CHABOT – LAS POSITAS COMMUNITY COLLEGE DISTRICT

Addendum No. 1 **INVITATION FOR BID NO.: 08-16** **M&O Facility Modular Office Building Manufacturing &** **Installation, Las Positas College**

LAS POSITAS COLLEGE
M&O FACILITY
MODULAR OFFICE
BUILDING -
MANUF. & INSTALLATION

A3.01

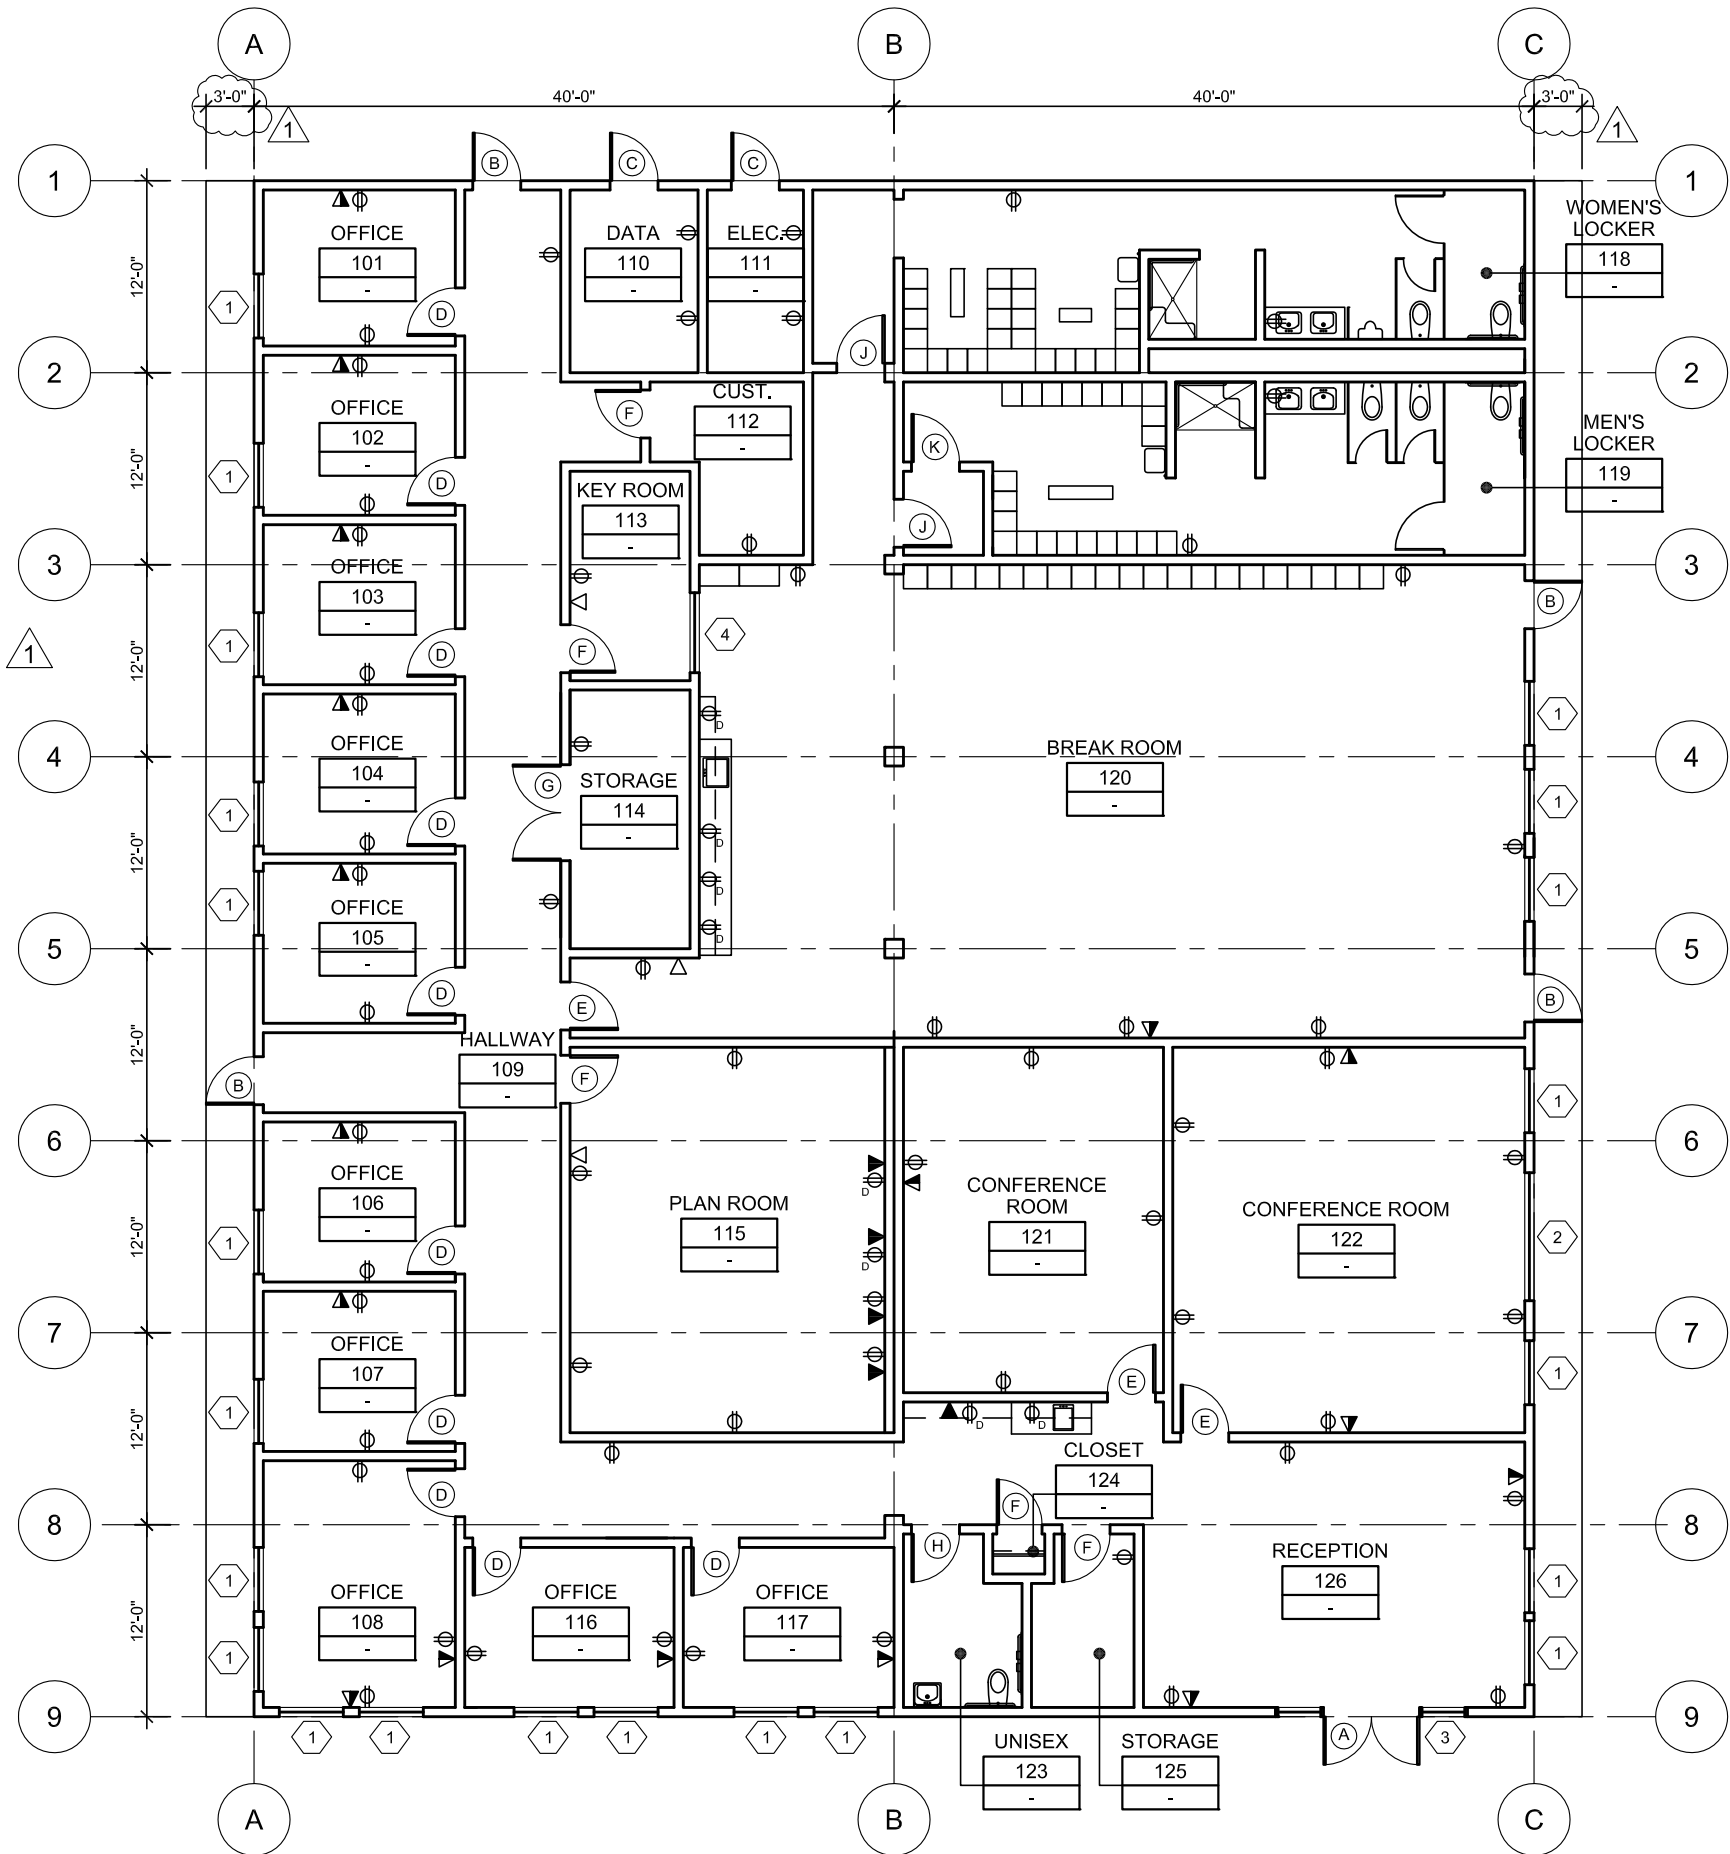
Item 4 Sheet A3.01 Office – Floor Plan (re-issued)

- A. Specifications:
 - 1. Modify paragraph 3 to indicate a minimum roof slope of 1/4:12.
 - 2. Add subparagraph 4.a regarding a bid alternate for MDO siding on the building exterior.

- 3. Modify subparagraph 5.b to indicate an 18” high clear crawlspace where plumbing fixtures are located.
 - 4. Add subparagraph 5.d regarding the preparation of a level building pad by the District’s sitework contractor prior to the modular manufacturer commencing the installation of the building foundations.

- 5. Modify subparagraph 8.c to indicate that the lockers in the men’s and women’s restroom are to be metal with factory applied enamel finish.
 - 6. Modify paragraph 9 to indicate that mechanical units are to be gas-fired.

- 7. Add subparagraph 12.a to indicate requirement for occupancy sensors.
 - 8. Add paragraph 19 regarding the pre-drilling of the steel roof framing for fire sprinklers to be installed by District’s site contractor.

- B. Floor Plan
 - 1. Add roof overhangs with dimensions.

Question:
Roof overhangs?

Question:
Gas or Electric?

Response:
Roof overhangs and dimensions have been added to the revised floor plan sheet A3.01 attached to this addendum.

Response:
Paragraph 9 of the specifications on sheet A3.01 has been modified to specify gas-fired mechanical units.

A8.01

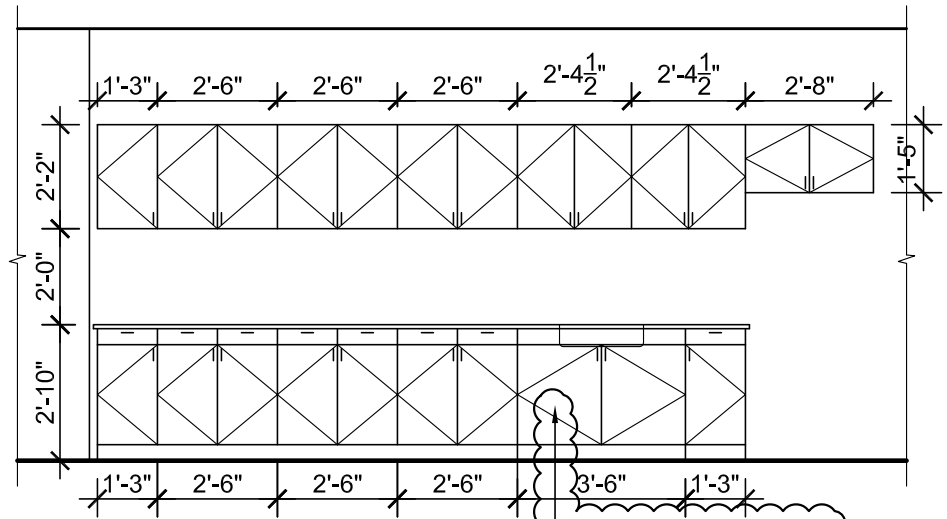
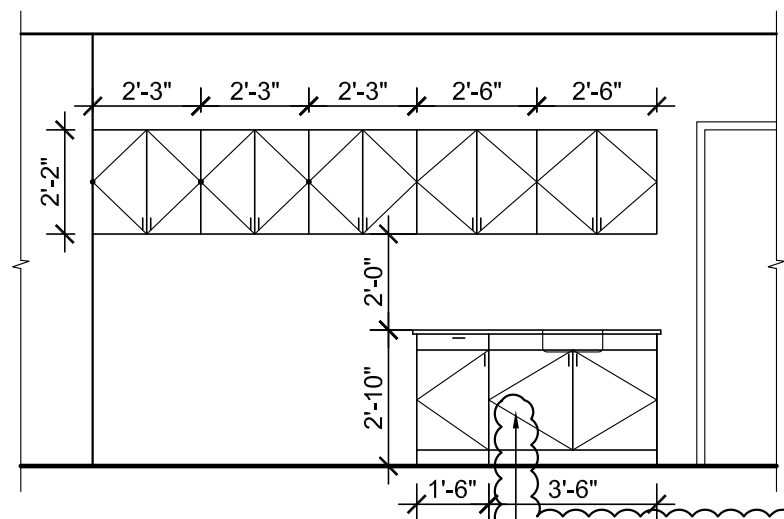
Item 5 Sheet A8.01 Casework Elevations (re-issued)

- A. Add note to Breakroom 120 and Reception 126 casework elevations indicating that sink cabinets are to be wheelchair accessible.
- B. Add note to Breakroom 120 and Reception 126 casework elevations indicating a requirement for adjustable shelving at the cabinets.

NOTE: PROVIDE (1) ADJUSTABLE SHELF AT EACH CABINET

ACCESSIBLE SINK CABINET
▲ 1

NOTE: PROVIDE (1) ADJUSTABLE SHELF AT EACH CABINET

ACCESSIBLE SINK CABINET
▲ 1

A10.01

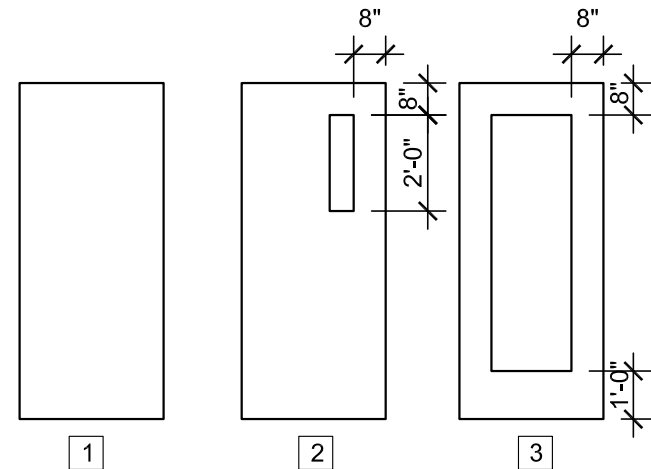
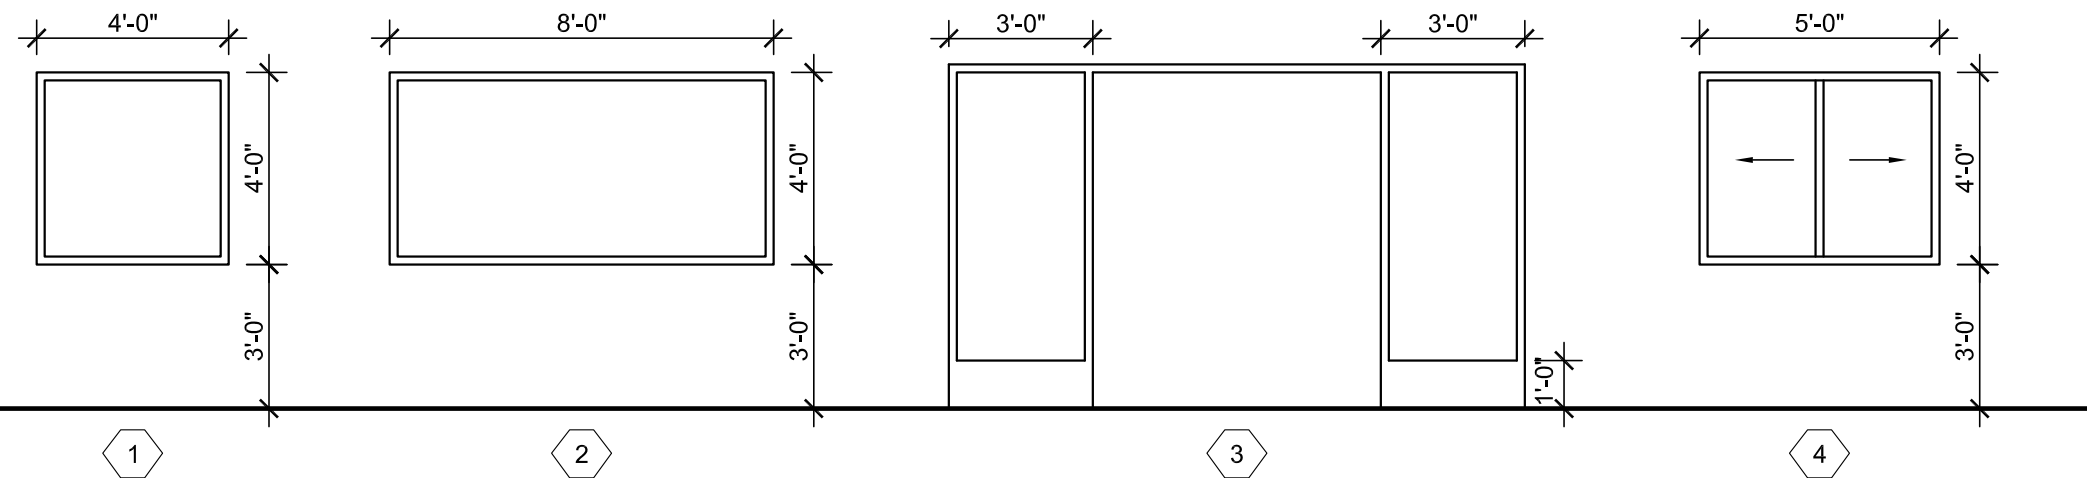
Item 6 Sheet A10.01 Window and Door Types, Schedules (re-issued)

- A. Door Schedule
 - 1. Revise identification of door types in door schedule to be consistent with numbering of door types in elevation.
- B. Window Schedule
 - 1. Modify window type 3 to be steel with a painted finish so that it is consistent with the door construction and finish identified in the door schedule.

On Sheet A10.01 please confirm that the door types should be labeled as "A, B, C" (not 1, 2, 3). See fourth column in Door Schedule.

Please clarify what type of Door - Window is specified for Door "A" Main entry at Reception Office: It is shown on the Window Schedule as an Aluminum window (Storefront??) 12' wide to accommodate hollow metal door type "C" (or 3 - see question 4 above). The window elevation on A10.01 for window "3" looks like it should be a Storefront system, but the Door Schedule indicates hollow metal. If the "Sidelight" windows are aluminum and the double door is hollow metal, it will be necessary to include wall framing between windows and doors. The header bar connecting the two sidelight windows is confusing.

The door types on the door schedule have been revised so that they correspond with the door types "1, 2 and 3". Refer to attached sheet A10.01.

Door -Window type 3 is a steel frame with steel doors flanked by a sidelight on each side. Refer to the revised window schedule on sheet A10.01 attached to this addendum.
